FACT SHEET FOR PACIFIC SHELLFISH – QUILCENE, LLC NATIONAL POLLUTANT DISCHARGE ELIMINATION SYSTEM (NPDES) PERMIT WA0041114

Entity review is a process for the permittee to review the draft permit and fact sheet to correct details or concepts that are factual in nature, which is before the documents are accessible for public review and comment. The following comments are from Pacific Shellfish, submitted by the engineering firm SLR dated September 20, 2022. The original comment submittal is attached to the end of the Responsiveness Summary. Also attached is a letter dated October 24, 2022 with the Permittee’s specific responses to modifications of practices and changes to the Hatchery’s discharges that reflect work towards meeting the compliance schedule put forth in the draft permit. Comments made on the merits or derivation of permit requirements have been categorized for Ecology to consider later after the end of the comment period.

Figure 8 – Outfalls, Waterbody, Hatchery Process, and Water Balance for each Department

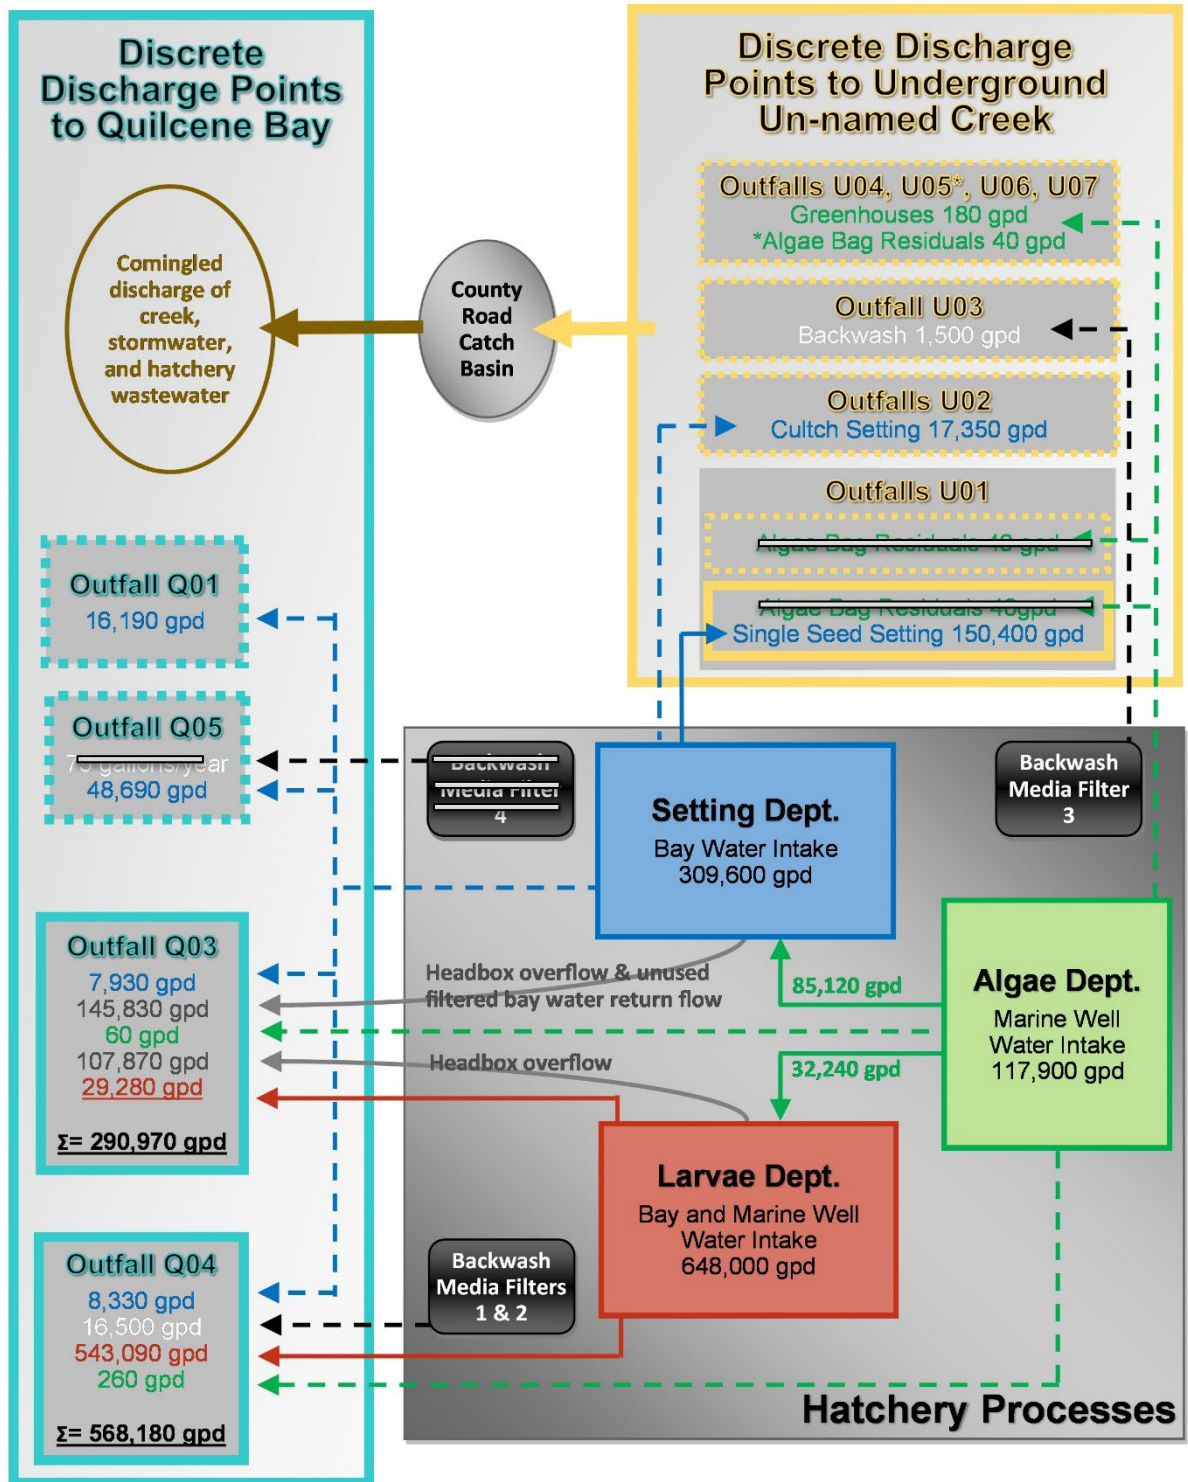
Comment: Fact Sheet Page 22, Figure 7

Should be Figure 8.

Page 22, Figure 7. Should be Figure 8.

Response:

Edited the fact sheet for this correction.

Figure 9 - NOAA Digital Elevation Model Shaded Relief Map of Quilcene Bay (noaa.gov) accessed 2/8/2022)

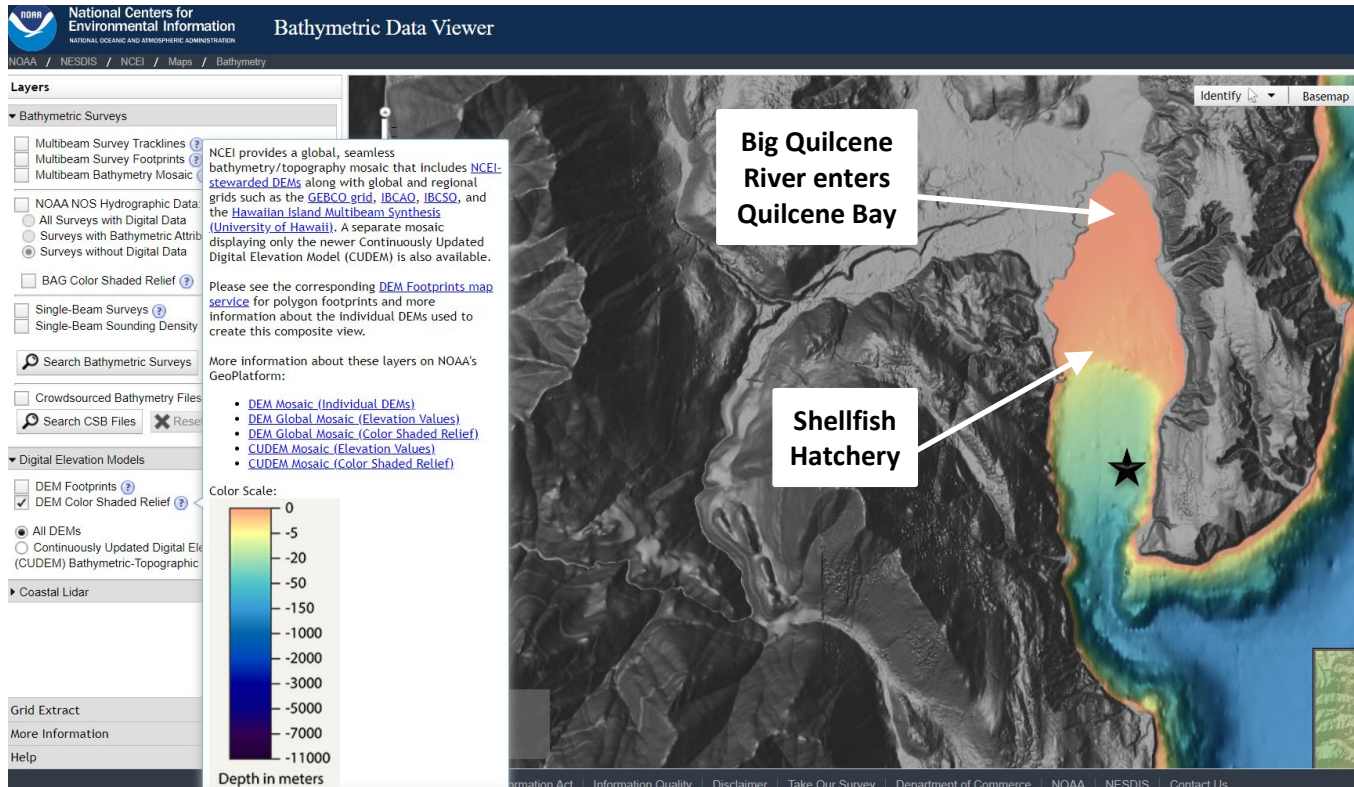
Comment: Fact Sheet Page 24, Figure 9.

The raft from which the temperature probes were mounted was approximately 3,000 ft north of where the arrow on the figure indicates. Also, the paragraph below the figure should be modified to specify that the temperature monitoring location was approximately a mile away and beyond the potential influence of the hatchery discharge and represents the natural background condition of the bay.

Page 24, Figure 9. The raft from which the temperature probes were mounted was approximately 3,000 ft north of where the arrow on the figure indicates. Also, the paragraph below the figure should be modified to specify that the temperature monitoring location was approximately a mile away and beyond the potential influence of the hatchery discharge and represents the natural background condition of the bay.

Response:

Edited the fact sheet for these corrections.
